A D D E N D U M #02

PROJECT: Salem Public Schools, Security & Hardware System Upgrades (phase 1B)

RE: Dr. Joseph Salerno Automotive Tech Center, Salem Public School, and Francis X Collins school

SOCOTEC JOB NO.: 182080.3.2

SEC.5

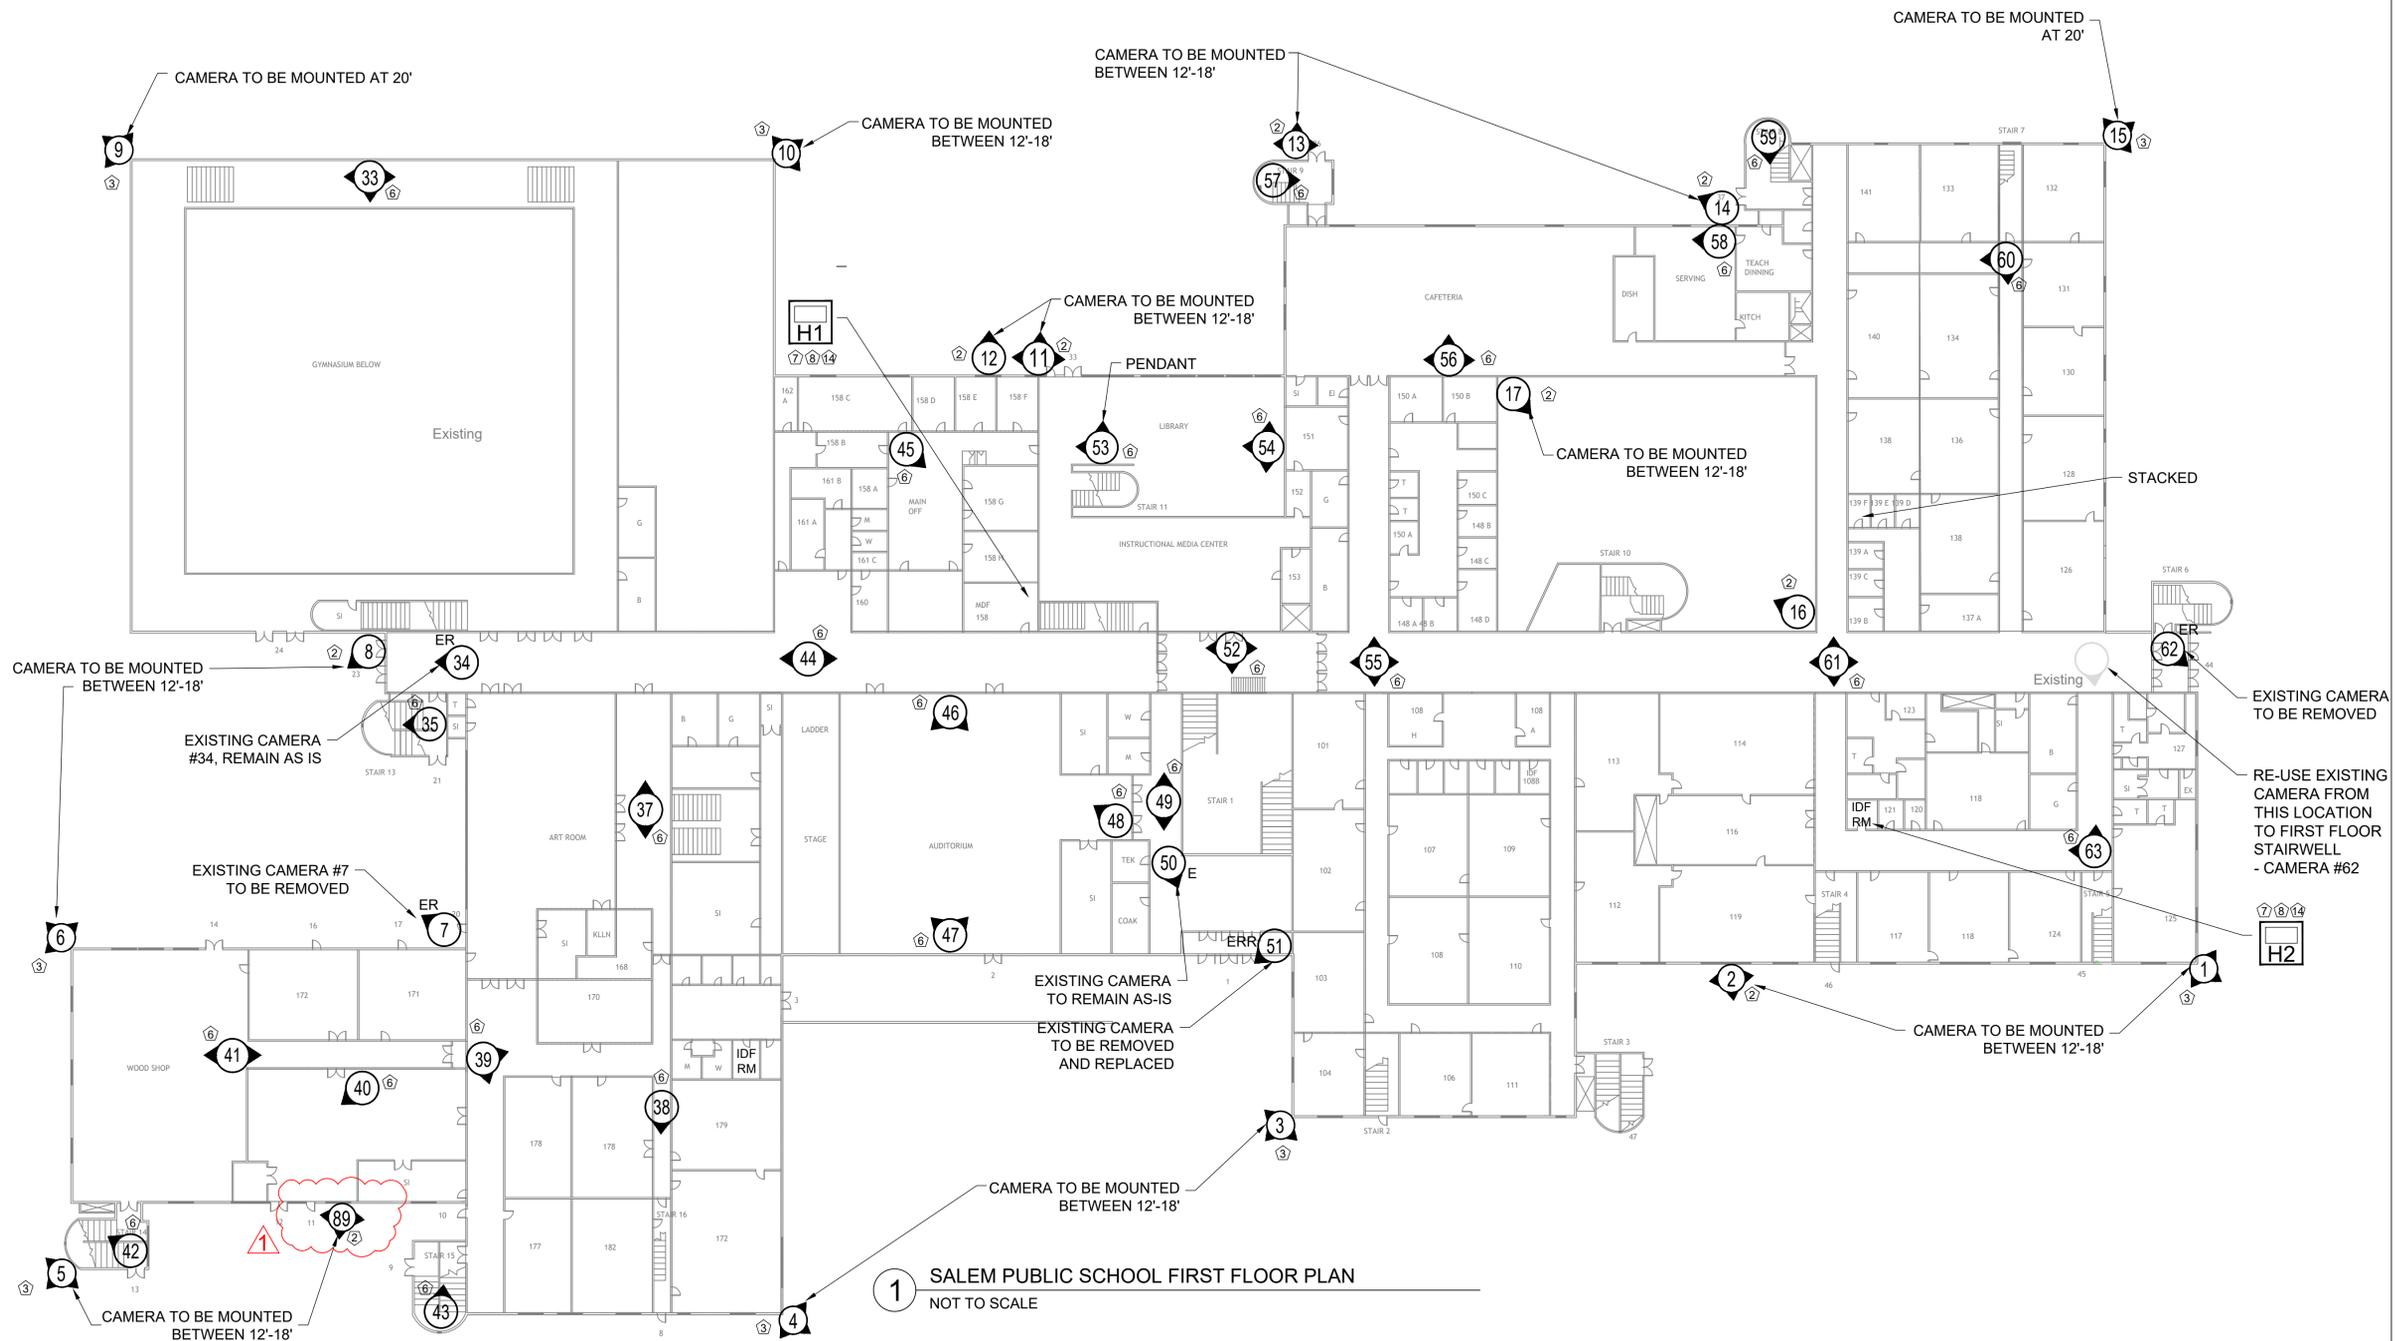
11. **Question:** *Sheet SEC.5, duplicate exterior C2, adjacent to stairwells 14 and 15, please advise.*

12. **Question:** *Sheet SEC.5, camera C50 is tagged to remain, equipment schedule SEC.18 shows C50 as an Axis P3715, please advise.*

Answer: Refer to the attached revised equipment schedule.

Answer: Refer to the attached revised equipment schedule.

SALEM PUBLIC SCHOOL RISER DIAGRAM AND FIBER INFRASTRUCTURE

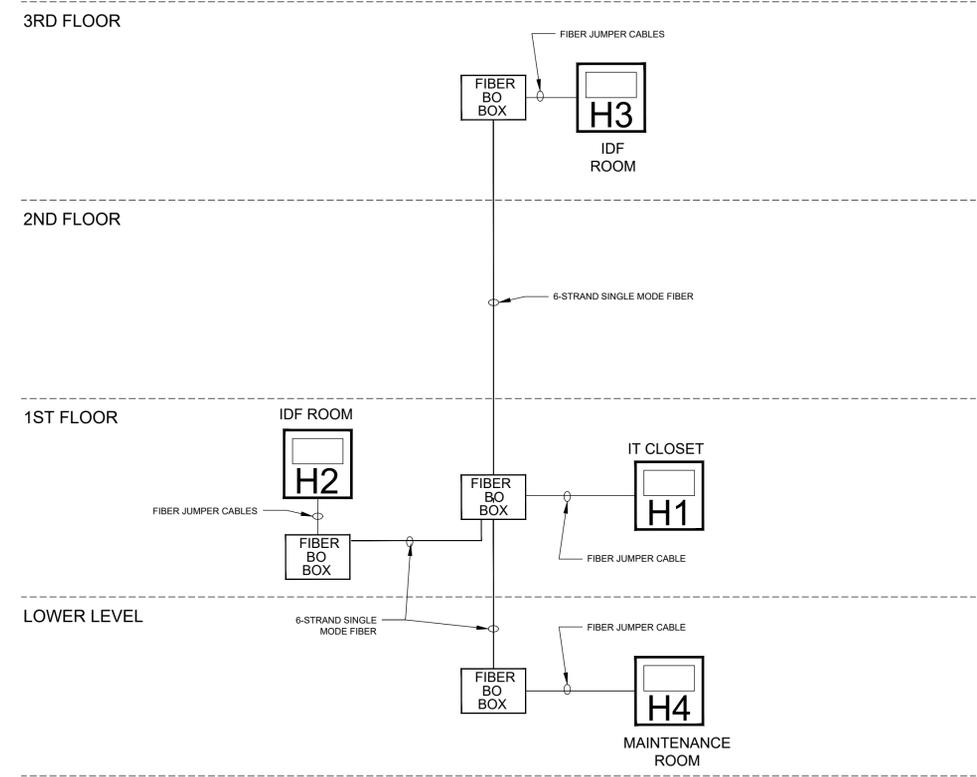
9. **Question:** *For camera cable runs that are over 300 feet, please advise for POE extending hardware.*

10. **Question:** *Please verify fiber optic cabling specification.# of Strands, Single mode, Multi mode, OS2, OM1-2-3-4, Armored Sheathing*

Answer: Specifications include Game Changer cabling (or approved equal) for the cameras that exceed 300 feet. If you prefer to utilize an Ethernet-over-UTP converter, the Nitek NV-EC1701U-KIT1 (or approved equal) may be used.

Answer: A minimum of 6-strand, 50-micron, OM3 cable shall be installed between the main head-end aggregation switch and each remote head-end. This cable shall be a Belden FL3D006A9 (or approved equal).
